**RE-EVALUATION
FORM****1. GENERAL PROJECT INFORMATION**A. Re-evaluation Type: Construction Advertisement, Design ChangeB. Original approved Environmental Document:**Document Type:** Type 2 CE**Date of Approval:** 02/19/2020**Project Numbers:**

Project Name: GOOD NEIGHBOR TRAIL GAP FR W OF SR 50/CORTEZ BLVD TO GOOD NEIGHBOR TR**Project Location:** FDOT District 7 (Hernando County)**Project Limits:** SR 50/Cortez Boulevard to Good Neighbor TrailC. Prior Re-evaluation(s):

**RE-EVALUATION
FORM****Good Neighbor Trail Gap**

from West of SR50-Cortez Boulevard to Good Neighbor Trail
Hernando County, Florida
WPIS: 437264-2

TYPICAL SECTION NO. 3
DARBY LANE / TOM VARN PARK
STA. 1065+24.71 TO STA. 1099+79.61

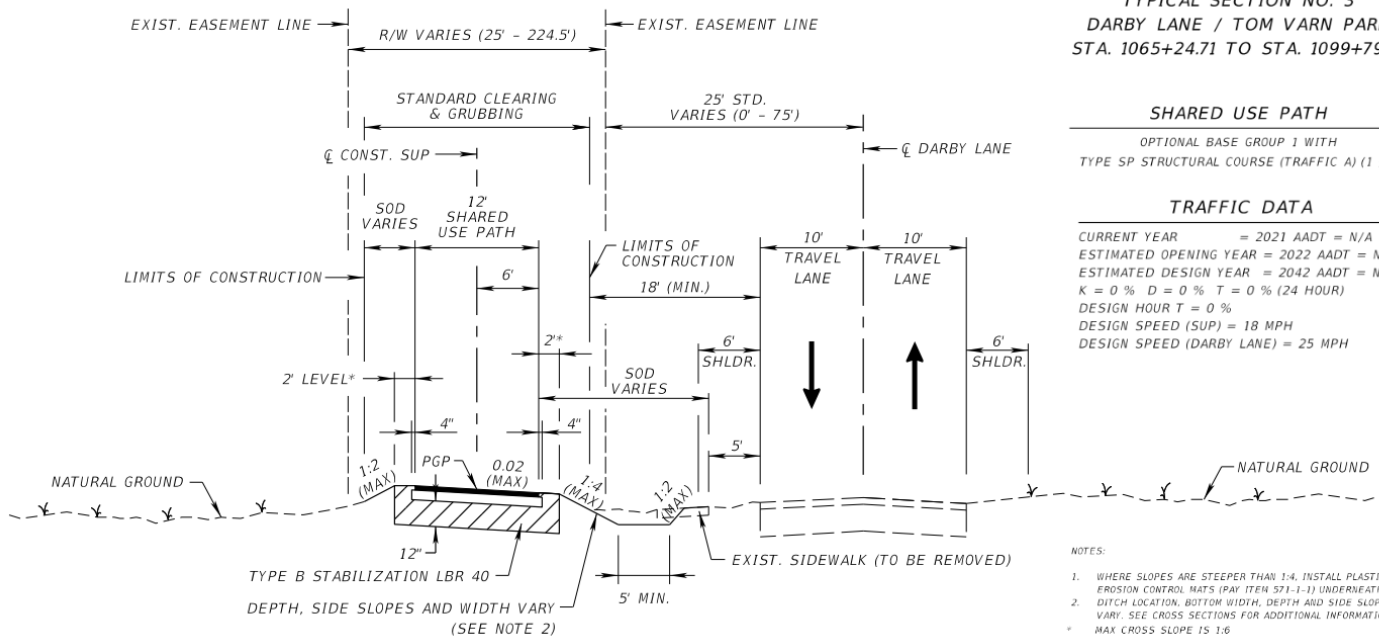
Median ditch added to the Darby Lane/Tom Varn Park typical.

TYPICAL SECTION NO. 6
SR 45 / US 41 / BROAD ST.
STA. 1126+85.50 TO STA. 2505+38.76

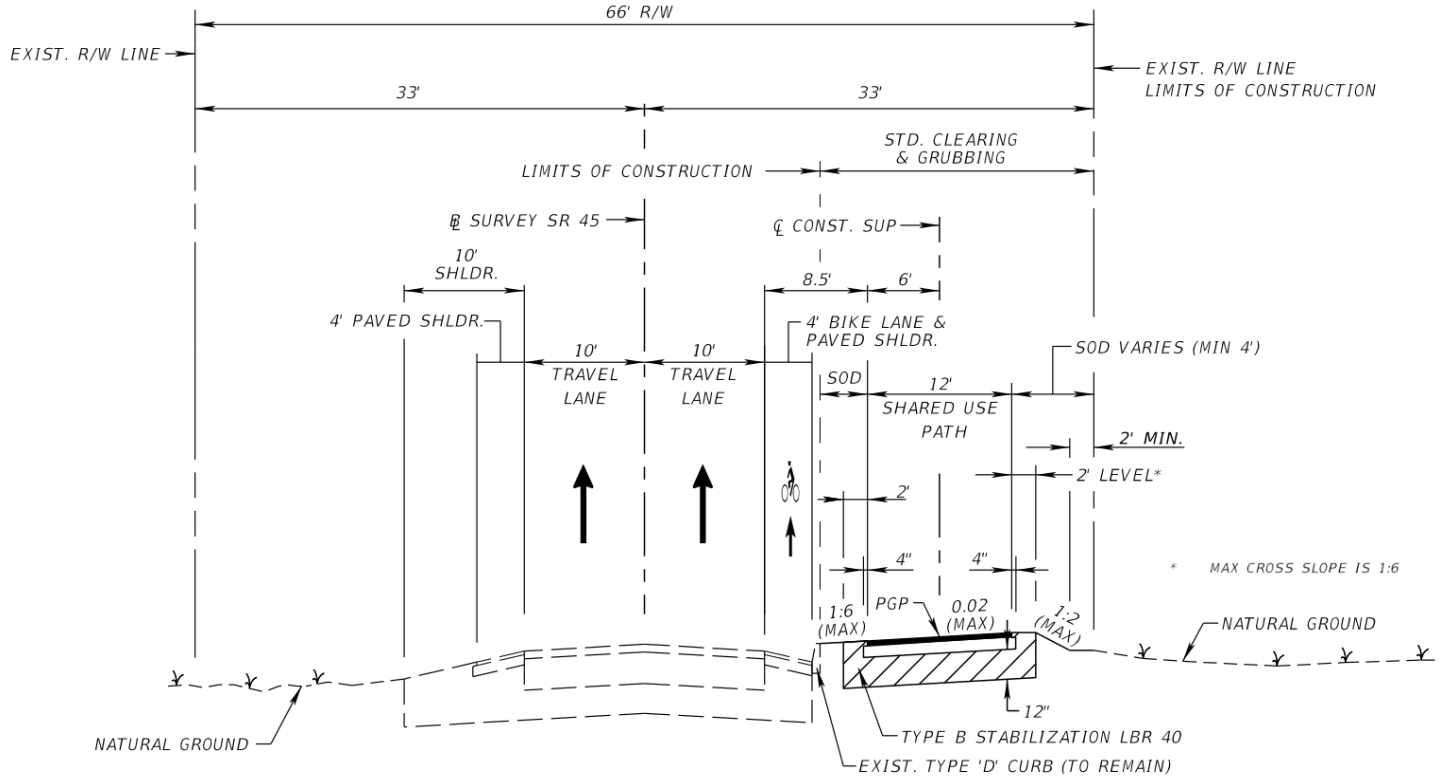
Existing bike lane added to the typical section along Broad Street.
